9.7.3 Blasting Noise and Vibration (2, 7)

11.2.1 Alluvium (5)

Figure: 5

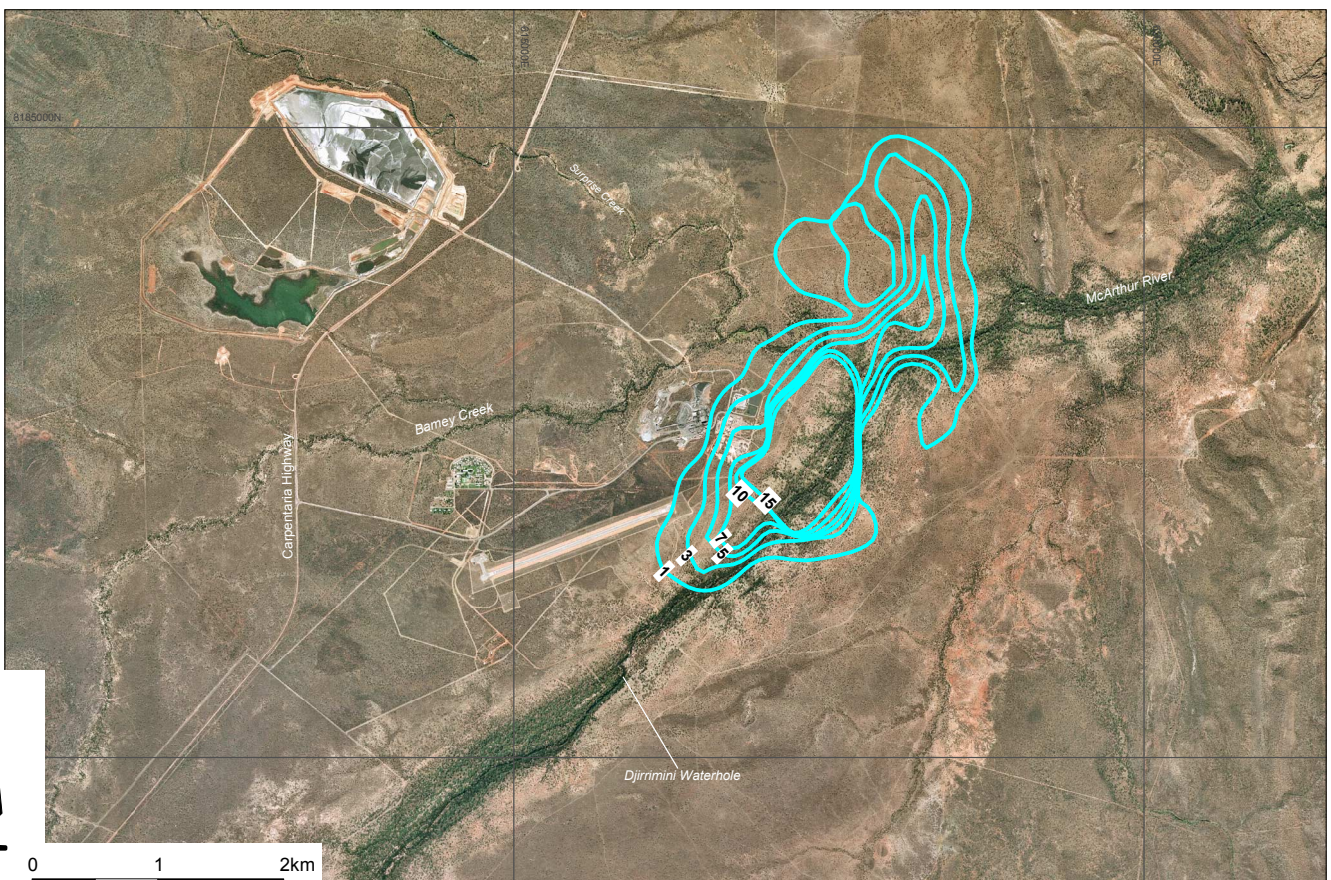
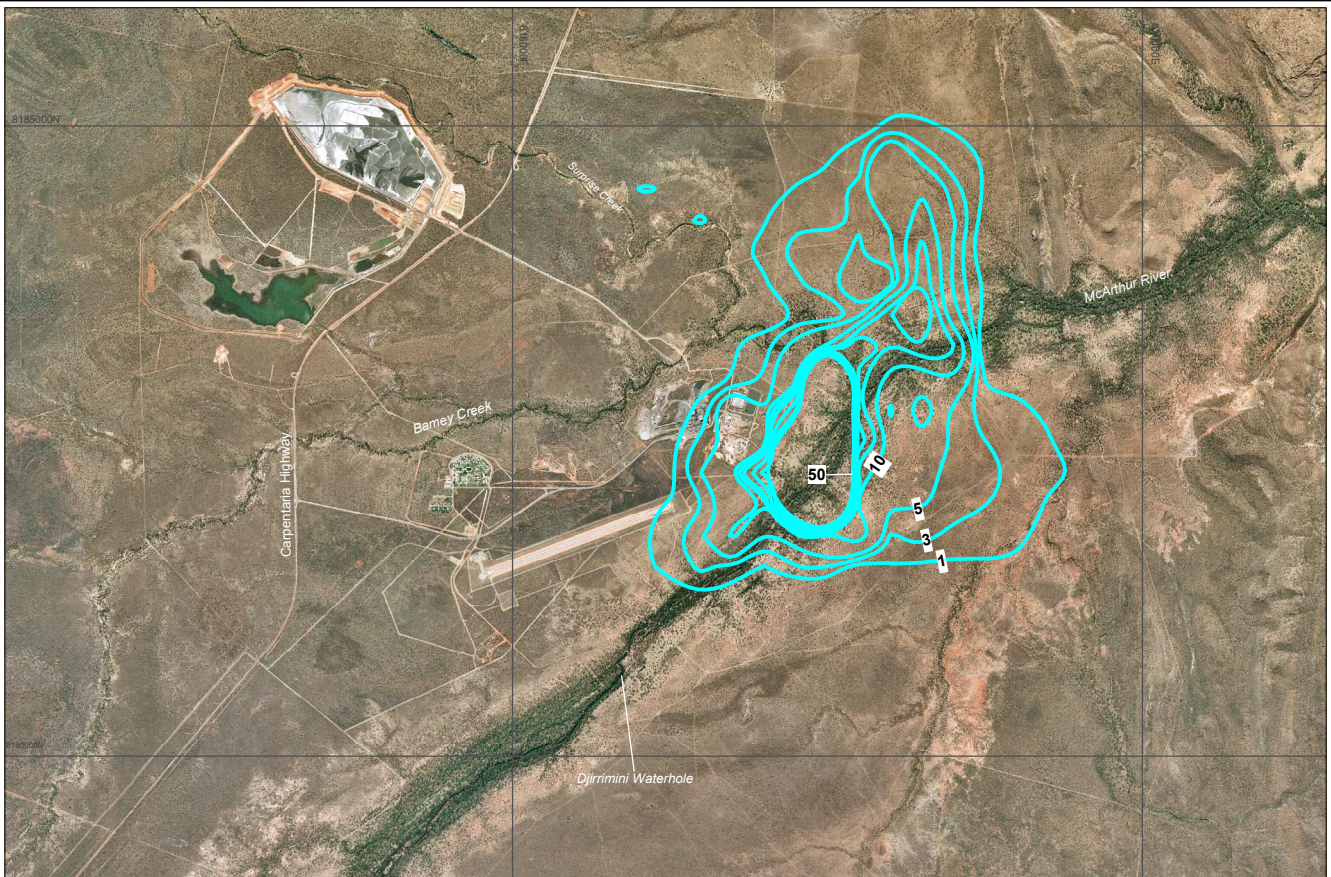
Figures 5 and 6 of this EIS Supplement show the extent of drawdown in alluvium and bedrock aquifers after 10 and 25 years of mining. These figures update the figures given in the draft EIS and are based on the refined hydrogeological model developed from the results of the additional groundwater investigations undertaken since the draft EIS was prepared.

Figures 5 and 6 show the modeled drawdown effects from the pit dewatering based on the refined conceptual hydrogeological model. The drawdown pattern is similar to that given in the draft EIS which was based on the initial conceptual model. Figure 5 shows the drawdown in Year 10 from both the alluvial and weathered bedrock aquifers and Figure 6 shows the effects in Year 25.

The revised drawdown pattern is similar to that given in the draft EIS which was based on the initial conceptual model

Figure: 2

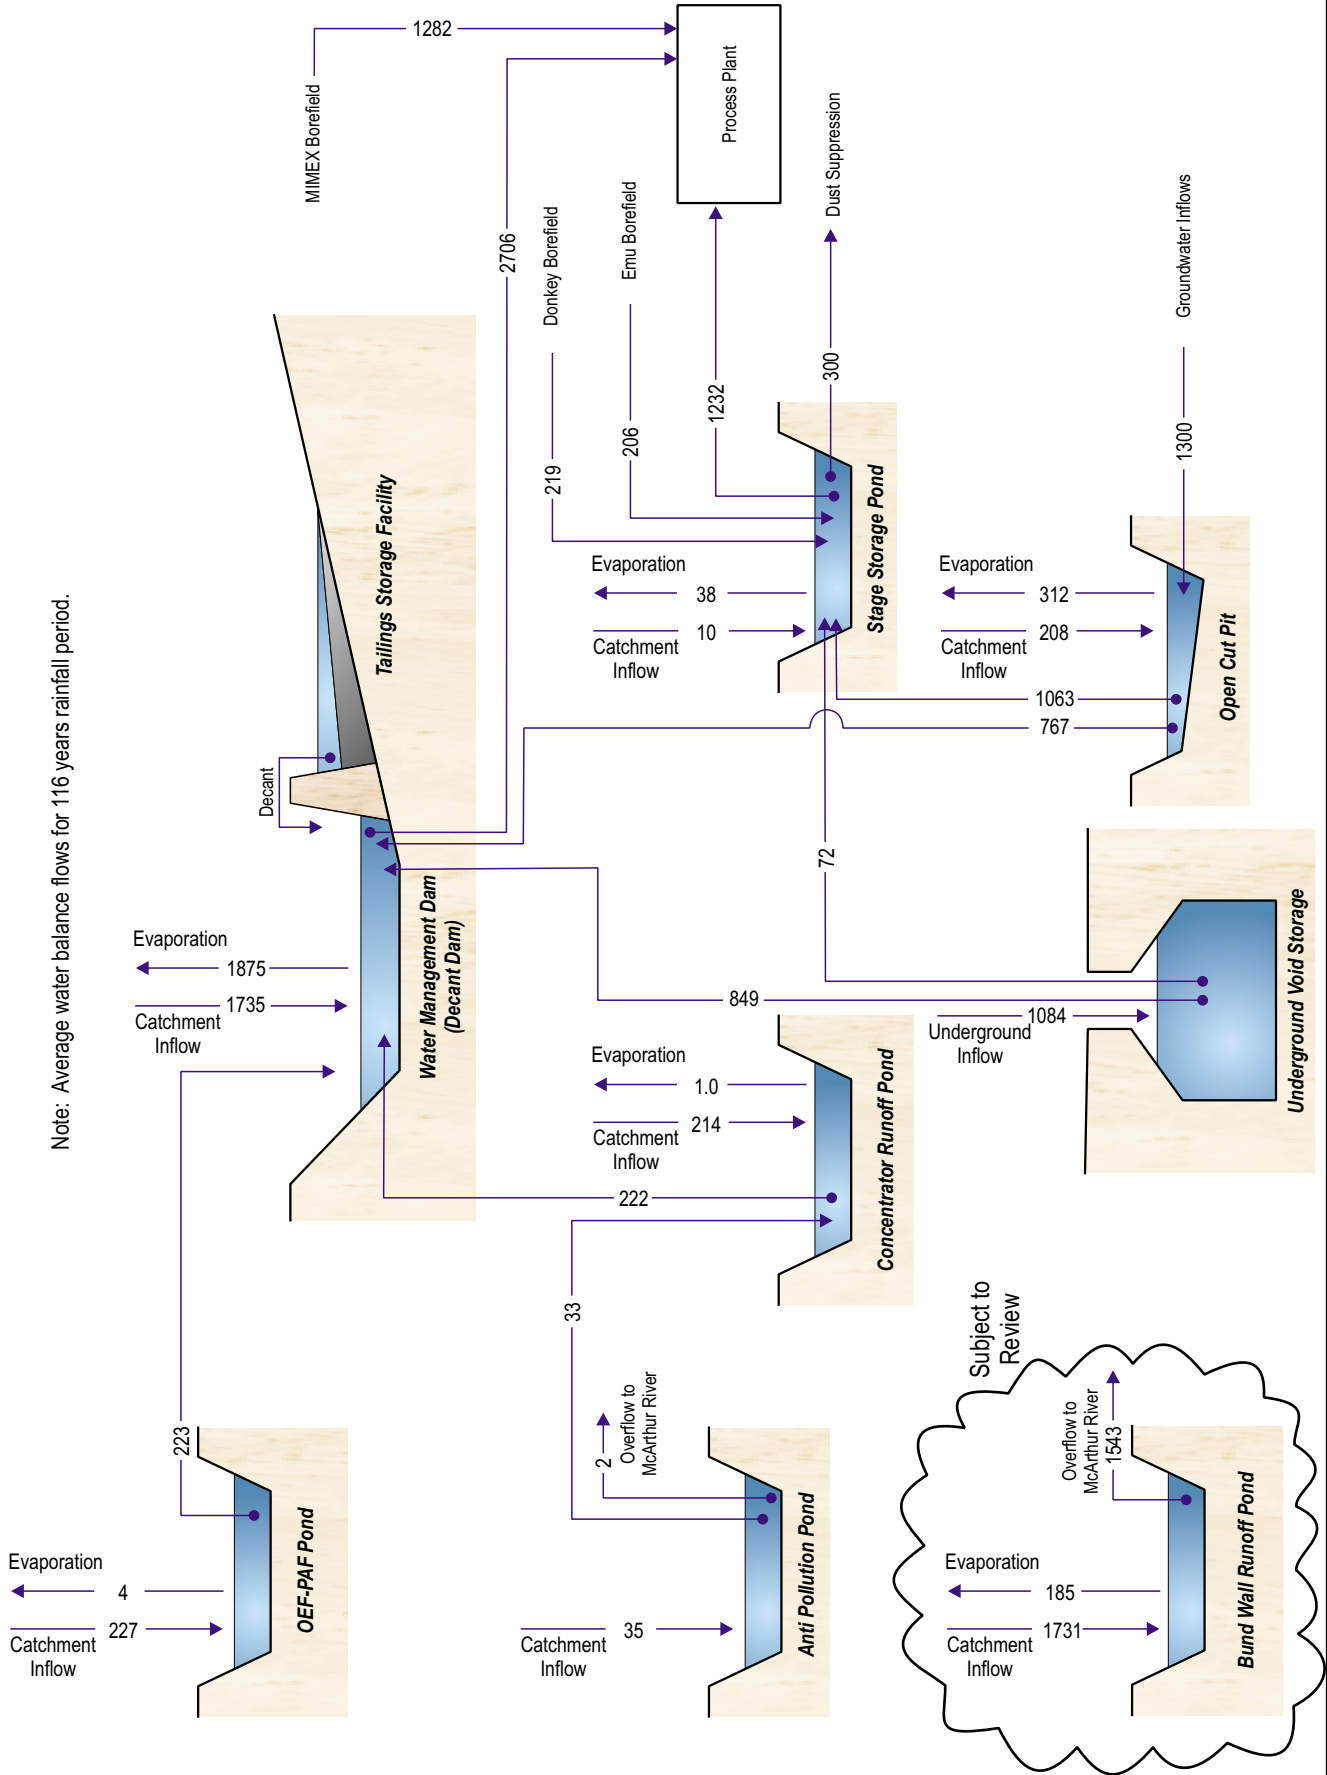
EPA has asked that Figures 12.11 and 12.10 in the draft EIS be updated to incorporate design volumes and median annual flow rates between each component of the water management system.

Annotated updates of Figure 12.11 (from the draft EIS) are provided showing mean annual water volumes between various components of the water management system. These are based on OPSIM modelling undertaken for mine water planning with 116 years of rainfall data to account for a wide range of possible climate conditions (particularly sequential rainfall events and wet seasons which often prove to be the most severe case). Two diagrams (Figures 2 and 3) are shown representing Years 1 to 3 and Years 4 to 17. The water balance for Years 18 to 25 will be evaluated during Years 2 to 5 taking into account the actual groundwater inflow monitoring data.

Figure: **3** Rev. A
A4

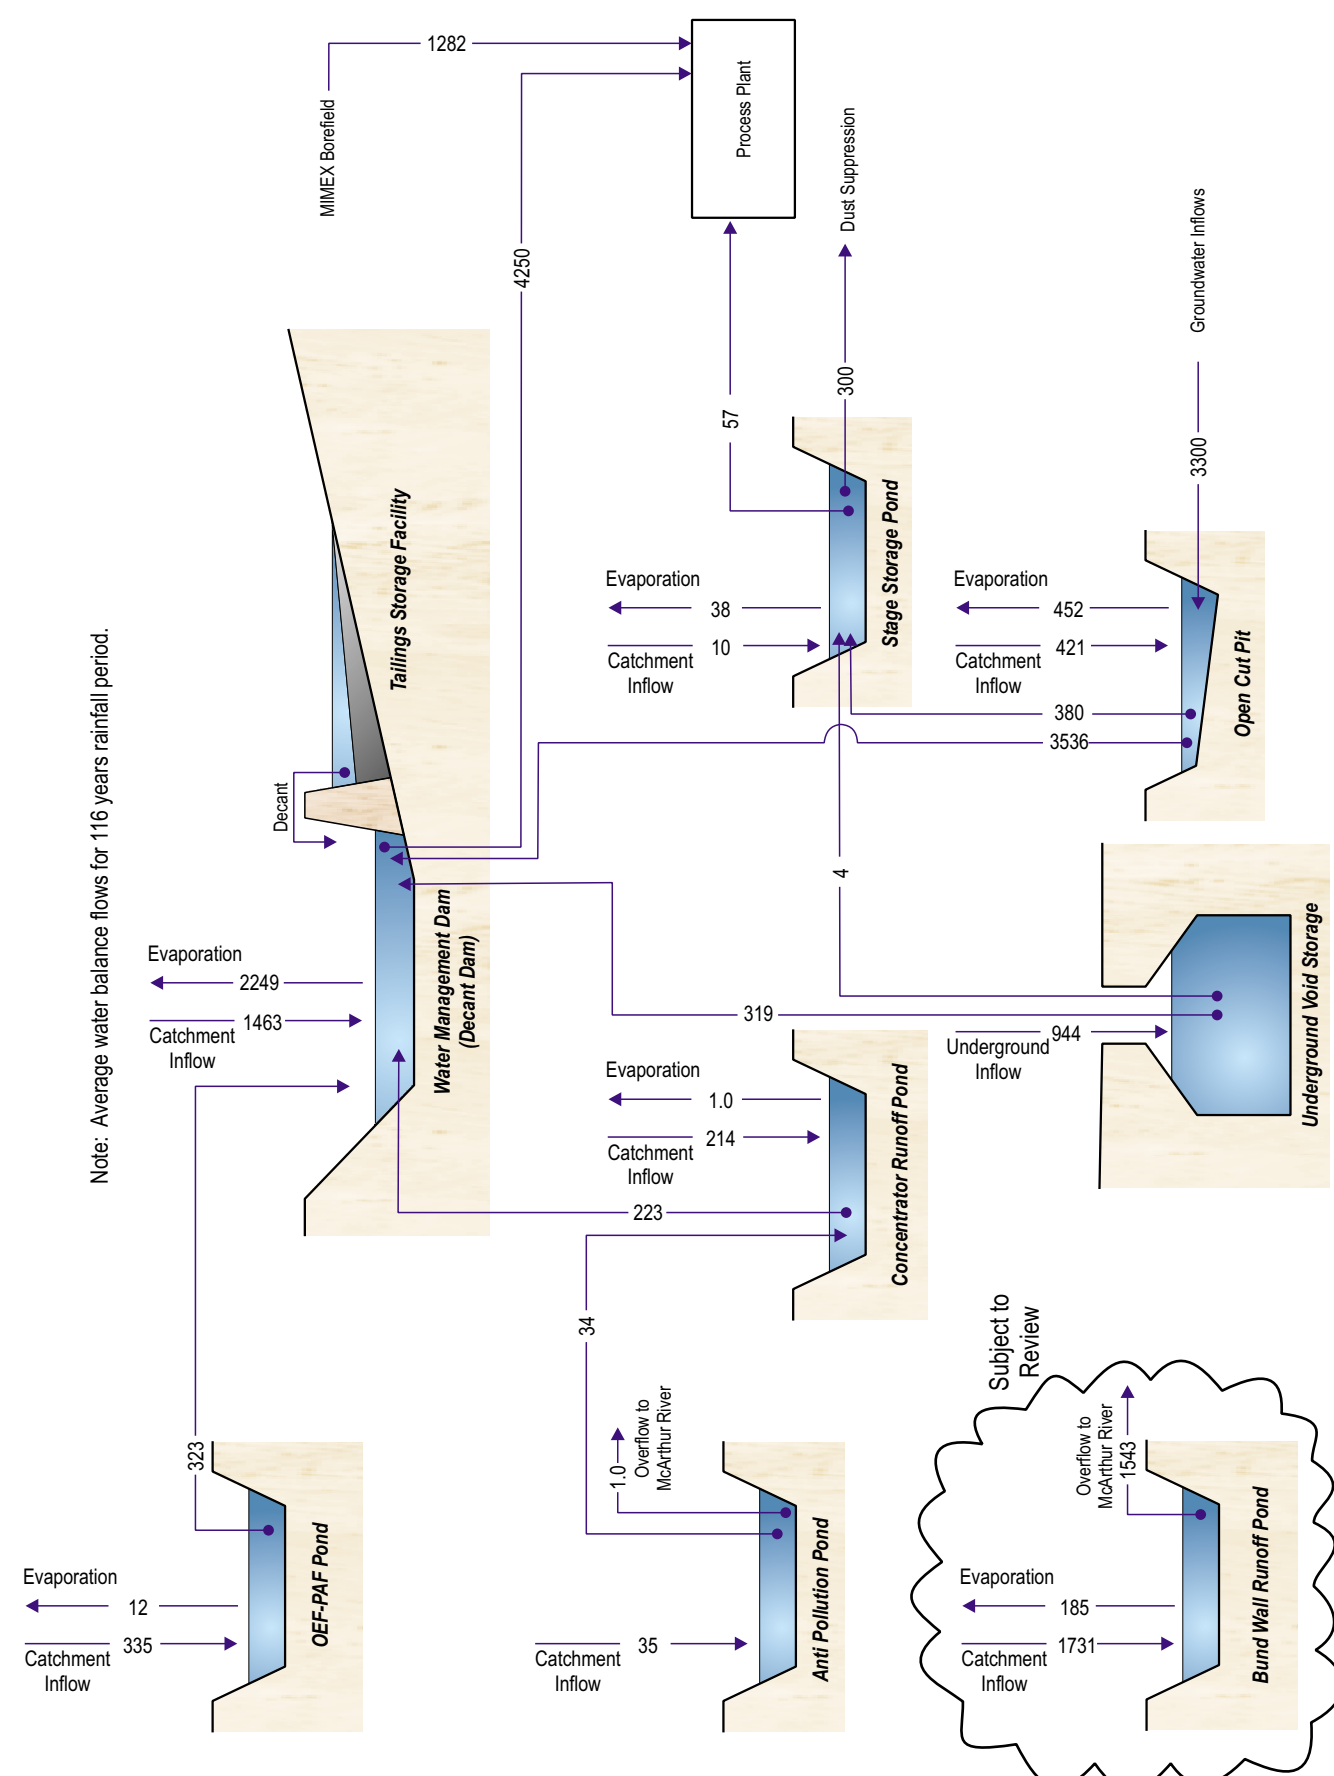
EPA has asked of runoff/seepage from the NAF pond be discharged to Barney Creek. They note that this is not shown in Figure 12.11 in the draft EIS. EPA asked what is the predicted volume coming from the NAF storage and is this volume included in the water balance calculations for the site. It also asked about the predicted water quality of the NAF seepage.
